Chirp From the Timing Belt Area

(Supersedes 08-045, dated May 21, 2010, to revise the information marked by the black bars)

REVISION SUMMARY

Under REPAIR PROCEDURE, step 8, a note about inspecting the timing belt auto-tensioner was added.

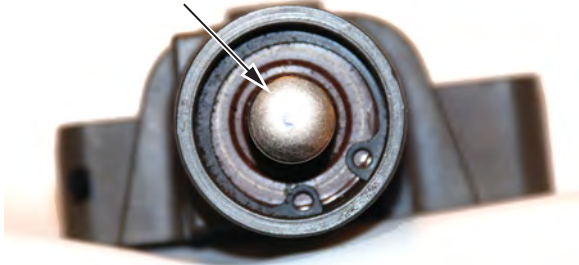
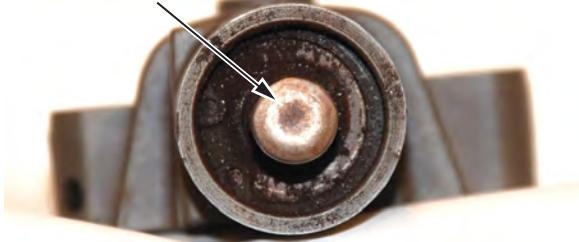
NOTE: Remove the timing belt auto-tensioner, and inspect the tip of the piston for signs of damage. Test the tensioner by pushing it down against a flat surface. The tensioner should not compress. Replace it if it is damaged or if it compresses.

**BACK SIDE OF THE
SIDE ENGINE MOUNT BRACKET**

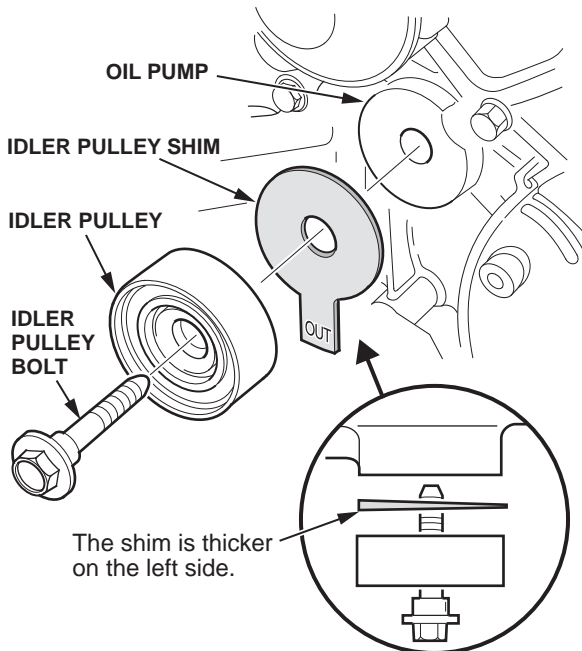
12. If the feeler gauge fit in step 5, go to step 13. If the feeler gauge did not fit in step 5, remove the side engine mount bracket. Using a die grinder with a 2-inch, 50-grit grinding disc (or equivalent) and the circular casting offset as a guide, grind the side engine mount bracket until the lip measures 2 mm thick with a caliper or a micrometer.

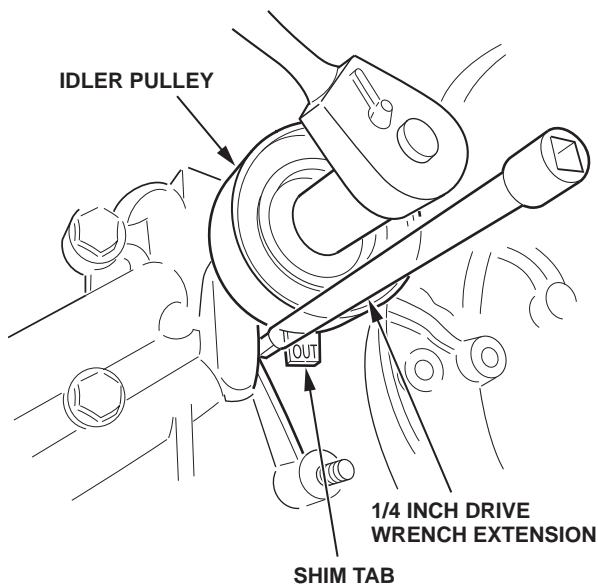
15. Place the idler pulley shim between the idler pulley and the oil pump housing, and loosely install the idler pulley bolt with Hondalock 1 applied to its threads. Make sure to follow the assembly instructions on the Hondalock 1 container.

NOTE: The shim tapers from left to right. The word "OUT" is painted in white and stamped into the tang of the shim, and should be readable when the shim is installed.
